TOWN COUNCIL
Work Session
Cape Charles Civic Center
October 23, 2024
6:00 p.m.

Mayor Charney stated that the item for discussion this evening was the Beachfront master Plan.

CAPE CHARLES Beachfront Master Plan MASTERPLAN

MONROE AVENUE PLAZA

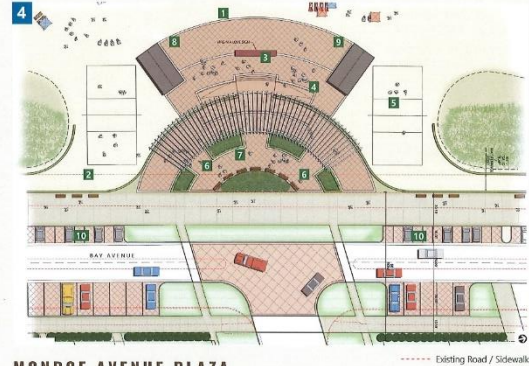
John Hozey asked if anything was needed at Monroe. Councilman Buchholz stated that there used to be an overlook at Monroe, adding that he liked the bump-outs at each street which would provide good areas for people to see the sunsets. John Hozey stated that something could be added that was more rustic.

CAPE CHARLES MASTERPLAN EXHIBITS

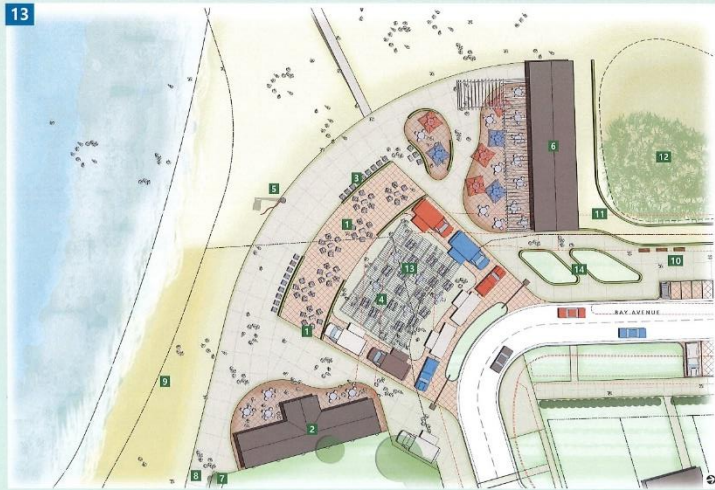
Councilman Grossman stated that item #1 (flexible gathering space) should be removed; #2 should be the bathroom; the front lane should be removed from #3 (food truck area); #4 (shade pergolas with food court) should be reduced; #7 (evergreen screening) should be removed; #9 (dog beach) should be removed; #10 (continuous wall) should be removed; #13 (food courtyard) should be reduced; and #14 (planting bed) should be removed.

RANDOLPH AVE PLAZA

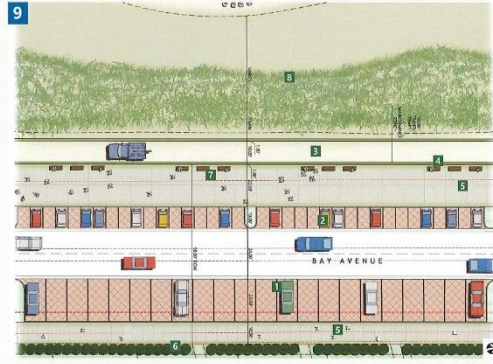
John Hozey stated that he heard that Randolph was a place to view sunsets. What else? Councilwoman Holloway suggested maybe 2 tables with chairs and asked if there would be a ramp to make the pavilion accessible to everyone as we were an aging community. There was some debate regarding the need for seating in addition to those in the pavilion. It was agreed to reduce the size of the plan shown on page 9 of the slides removing everything except for possible built-in seating
